TITLE: Sheet_1		REV: 1.0
	Company: Your Company	Sheet: 1/1
	Date: 2023-10-05 Drawn By: Denjhang

TITLE: Sheet_2		REV: 1.0
	Company: Your Company	Sheet: 1/1
	Date: 2023-10-05	Drawn By: Denjhang

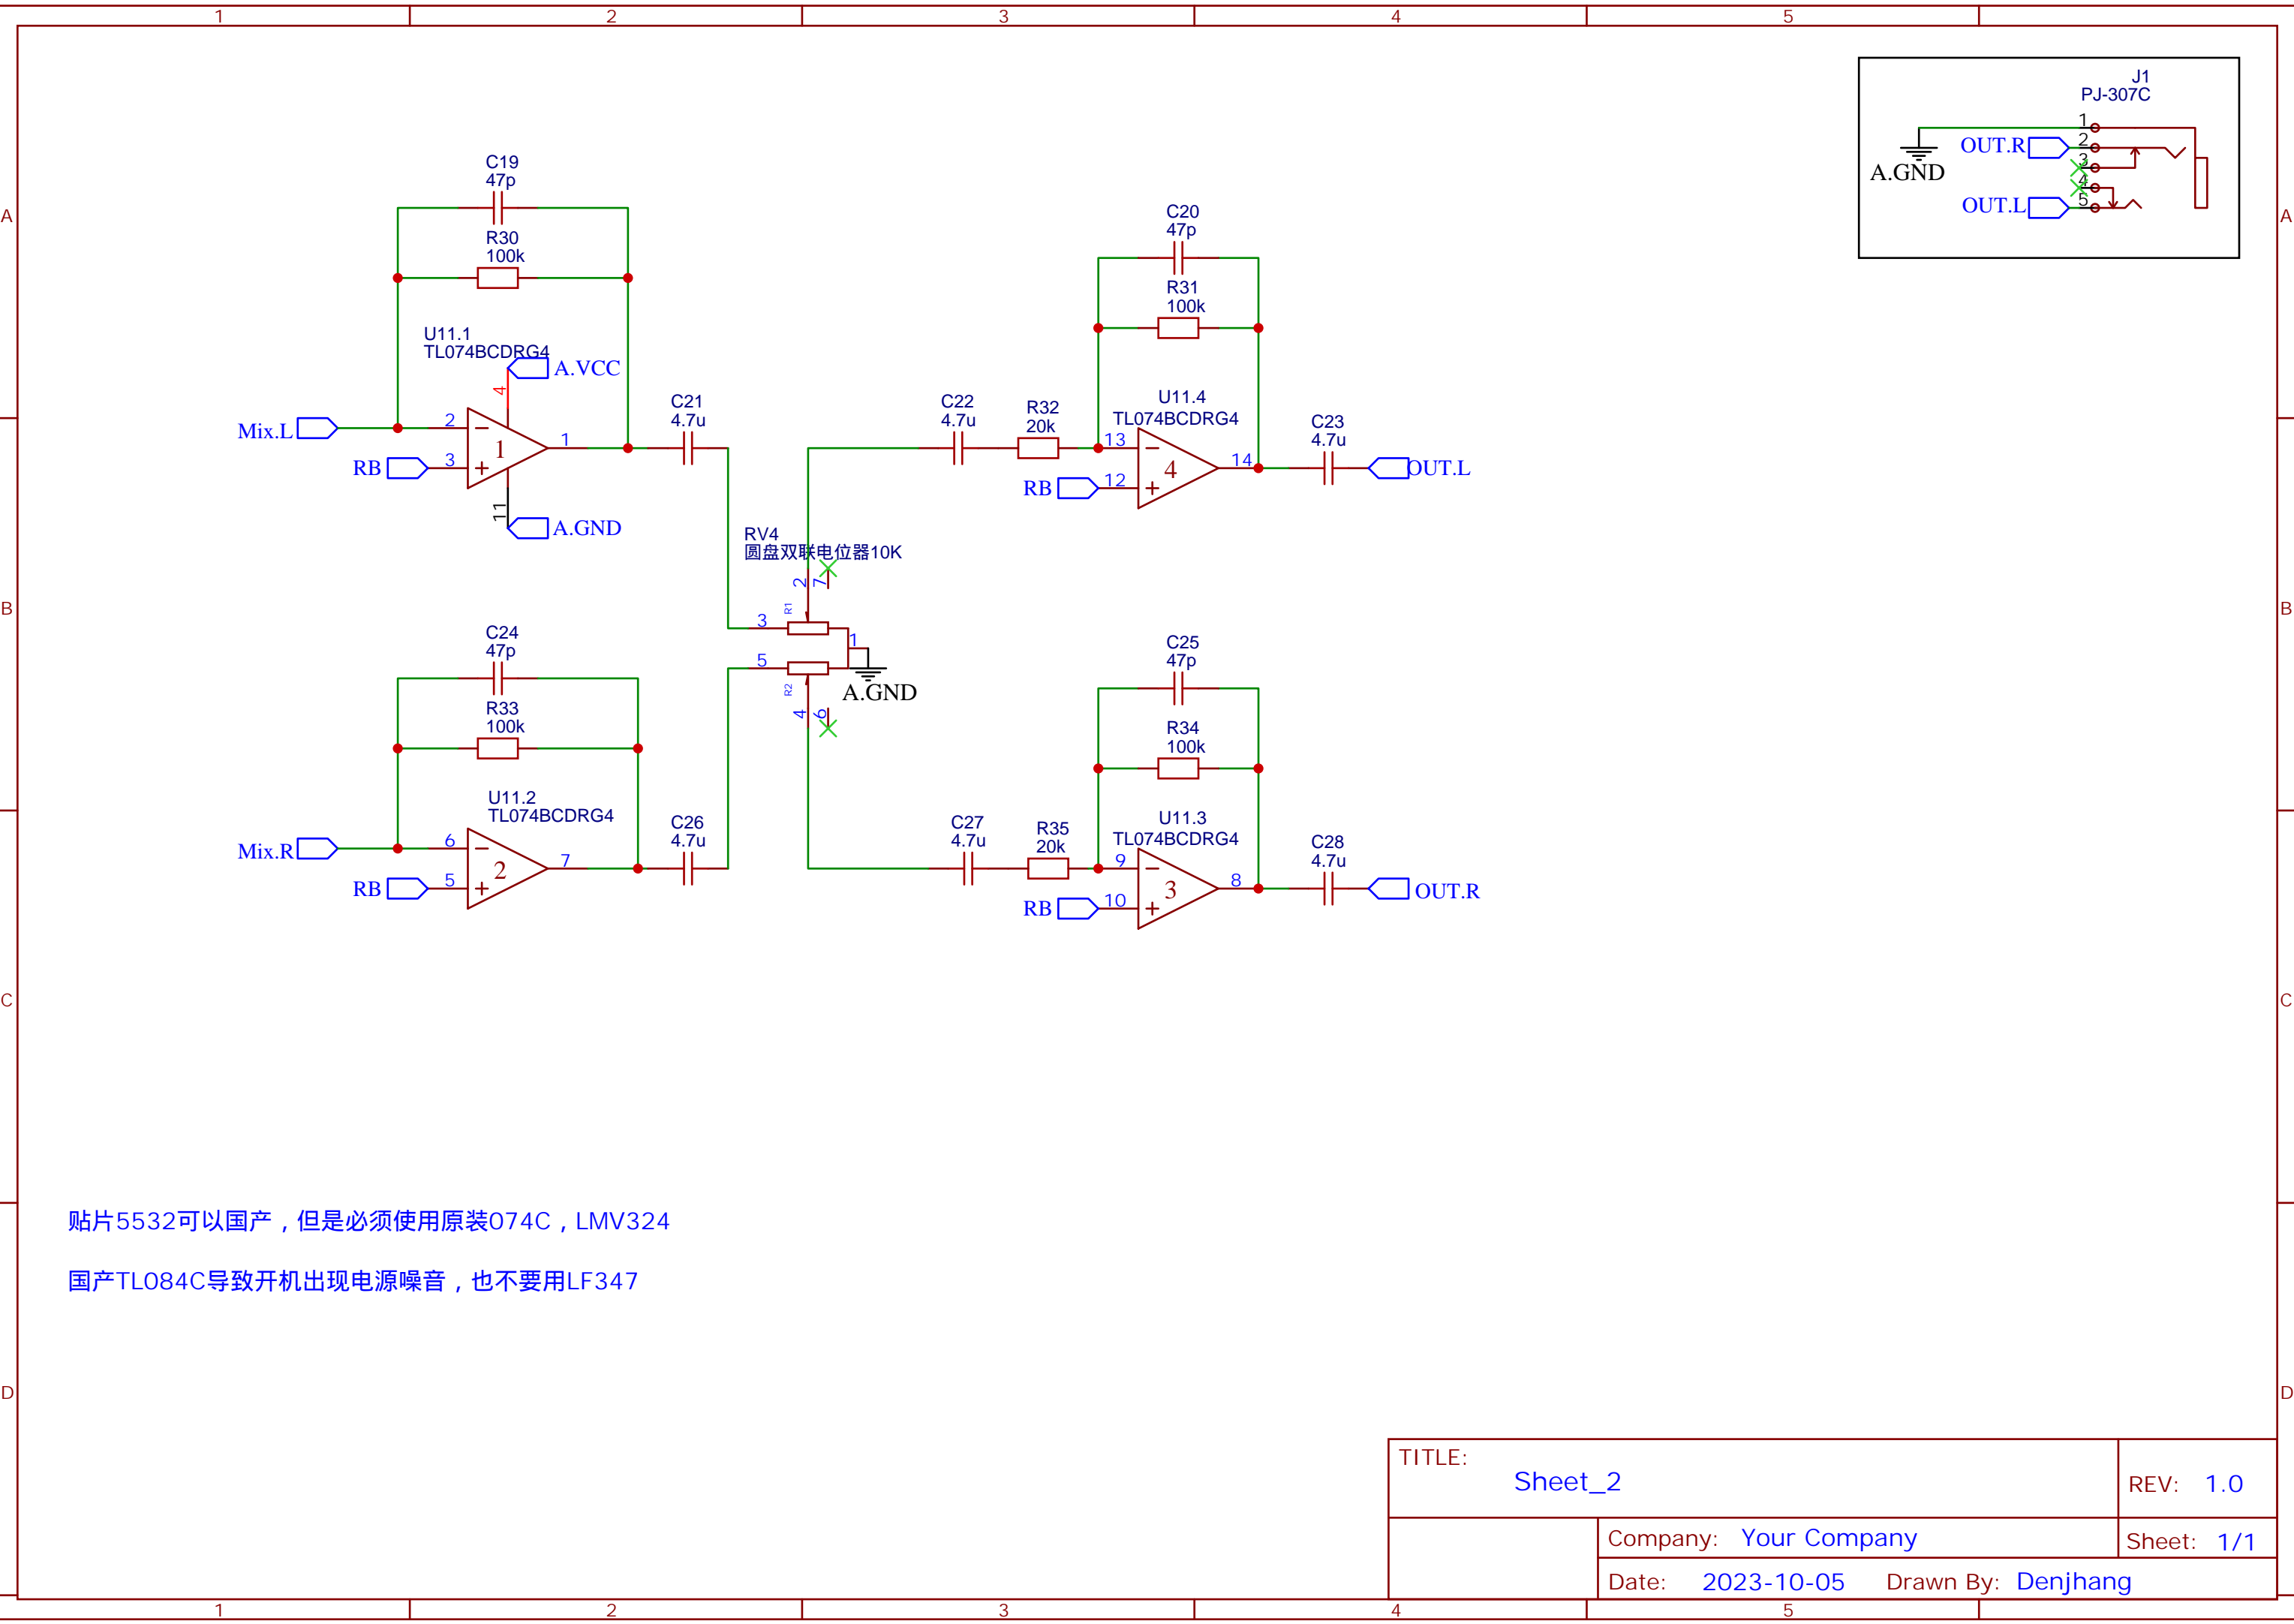
贴片5532可以国产，但是必须使用原装074C，LMV324

国产TL084C导致开机出现电源噪音，也不要LF347
